OFGEM

AQUILA

**DPCR4 – FBPQ ANALYSIS AND
CAPEX PROJECTIONS**

OCTOBER 2004

Figure A.3.2.1 - Forecast activity for plant on the secondary network (extract from Aquila FBPQ)

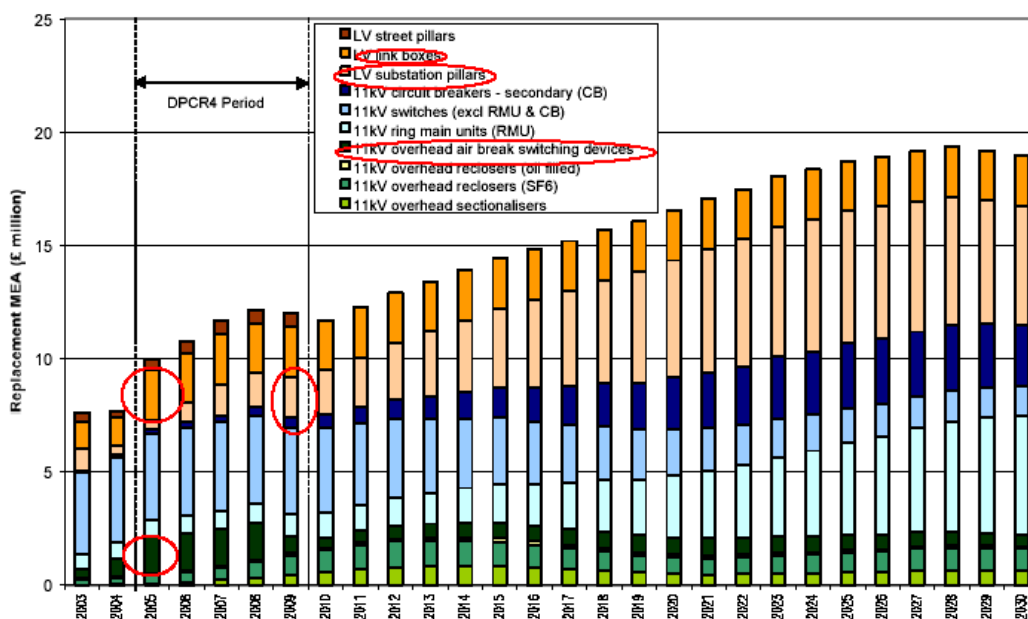
The activities circled above represent those areas that are forecast to increase significantly compared to DPCR3. This includes the following asset replacement:

LV Link boxes are forecast based on condition inspection reports. As may be noted a stepped increase in DPCR4 compared to DPCR3 does exist. This is attributed by Aquila to increased asset management activity identifying a safety related issue. As such, Aquila has sought to invest £10m in replacement over the period DPCR4. Condition reports on LV Link boxes have indicated that of those inspected 18 percent are in a high-risk state. It is therefore proposed to replace 10% of the asset population in DPCR4. This data forms the basis of the volume forecast. The replacement rate for link boxes is at odds with the industry replacement rate, but is consistent with Aquila's DPCR3 volumes. This difference between industry and company is difficult to reconcile. However, specific asset replacement policy is the responsibility of the company and hence the variance observed may well reflect a different investment focus.

The forecasting of street pillars is similar to that of LV network link boxes. The asset condition reports provided by Aquila support based on safety grounds this replacement. Aquila has ramped up this investment and made provision to replace this asset type with underground network link boxes. This asset is a non like-for-like replacement and more expensive. The argument proposed for this replacement type is based on increase network security. This non like-for-like replacement decision is arguably an enhancement over Base Case however the level of investment deemed appropriate for a particular asset is an individual company decision.

LV Overhead Air Break Switch Devices (ABSDs) are forecast for replacement on safety grounds due to operational restriction. Aquila has advised that it intends to replace all ABSDs in that regard consideration as to what level of replacement is undertaken and the degree to which replacement provides betterment with regard to improvements in system automation may be an issue.

Figure A.3.2.2 - Forecast activity for overhead line on the secondary network (extract from Aquila FBPQ)

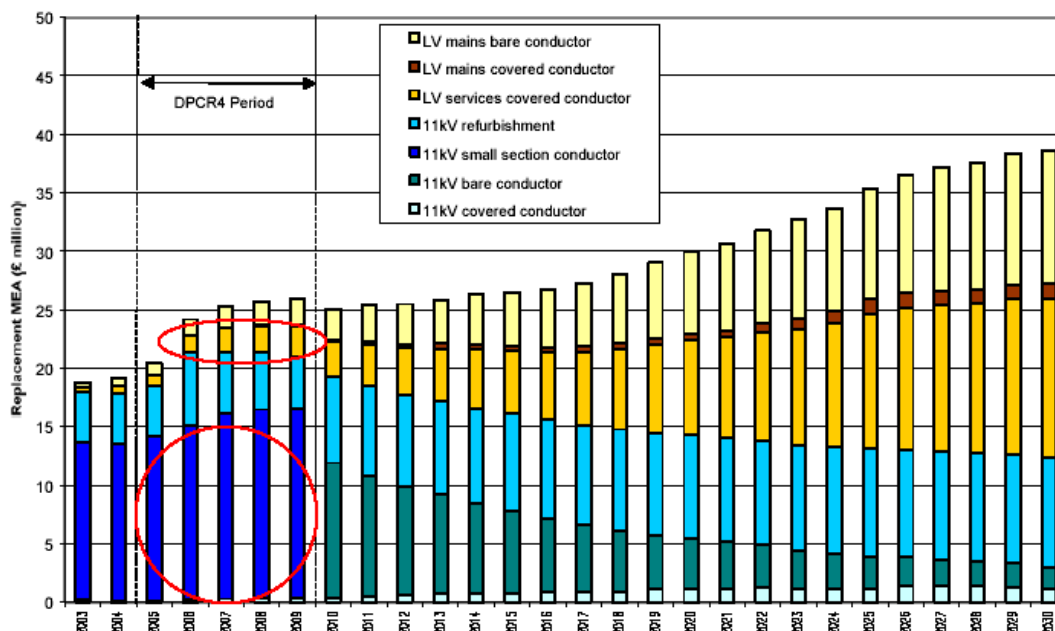
The secondary overhead line programme indicates a stepped increase in DPCR4. This increase is due to work programmes associated with:

Aquila has forecast to replace 50km of LV services. This replacement is to be undertaken at the same time as LV mains replacement. The replacement need is not based on an increase in fault activity or maintenance of network resilience. The rate of replacement does not appear excessive when compared to the total volume of the asset type some 11,000km. Using UK mean lives and historical replacement rates Aquila indicates that replacement activity for this asset has been low and that this stepped increase in activity is a result of a need to catch-up on previous low replacement rates. However, this is an improvement to the network over and above the Base Case. Aquila has also tied this programme to its LV mains programme and in that regard any shift in replacement activity of that asset may adversely impact on LV service expenditure.
